## Audit Findings & Follow-Up Exercise

Number	ADR.813	Requirement	CAP 168 Licensing of Aerodromes	
<b>Details</b>				
Declared Distances				
The declared distances for runway 06 LDA were found to be incorrect. For runway 06 LDA they are declared to the runway end lights, but these are not at the end of pavement which is where LDA is measured to. The airport should either reduce LDA to 747m or move the runway end lights.				
Additionally, the strip width on the 1560C is incorrect (CAP 168, 3.44); it should be 41.5m either side of the runway centreline.				
Level	Status	Target Date	Closure Date	Raised By
2	Closed	30/06/2018	02/10/2018	Graeme Ritchie

Runway  
end lights

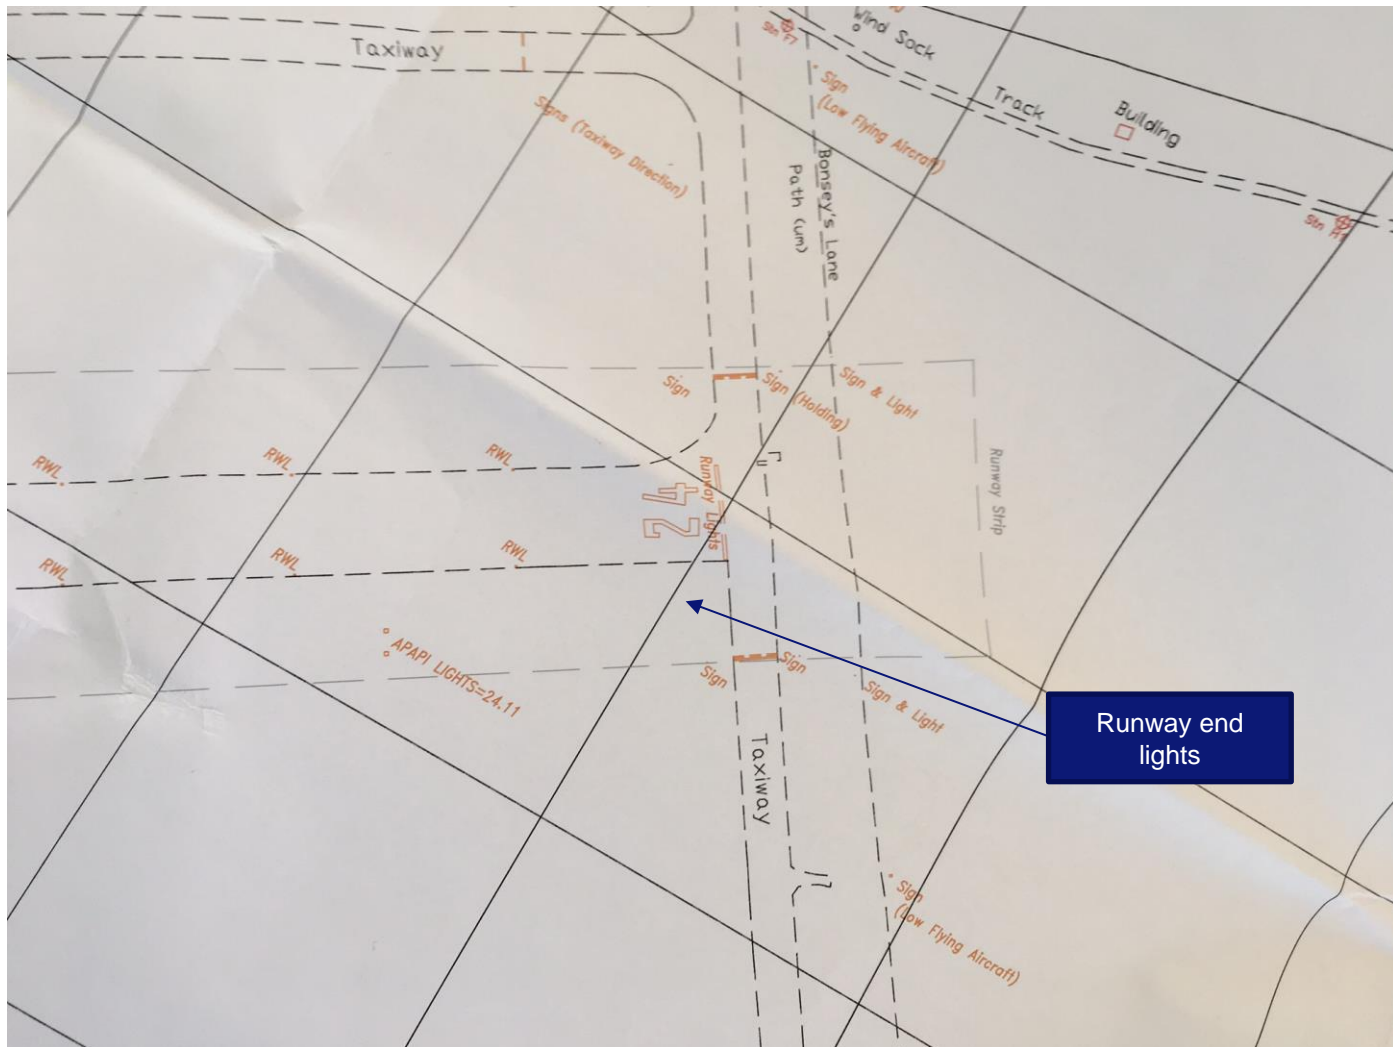
- You are on audit and find the following:
  1. The AIP chart shows the runway 06 stop end lights at the end of pavement
  2. The aerodrome survey shows the runway 06 stop end lights at the intersection of the runway and the taxiway across the runway end
  3. A photograph onsite confirms that 2 is correct.
  4. The agreed declared distances state that the TORA and ASDA end at the end of pavement
- Actions
  1. Is this a finding or an observation?
  2. If yes, is it a Level 1 or Level 2?
  3. Draft your audit report item covering this.

- a) Amending CA1560C to show that the LDA ends at the end of the paved surface, thus retaining an LDA of 760M.
- b) Inserting into the AIP, EGTF AD 2.20 Local Traffic Regulations, a warning to the effect *"Caution, the LDA and paved surface for runway 06 ends 13 metres beyond the runway end lights"*.

- c) Submitting an AIP change to update the Aerodrome Chart at AD 2-EGTF-2-1 to correctly depict the location of the runway end lights.
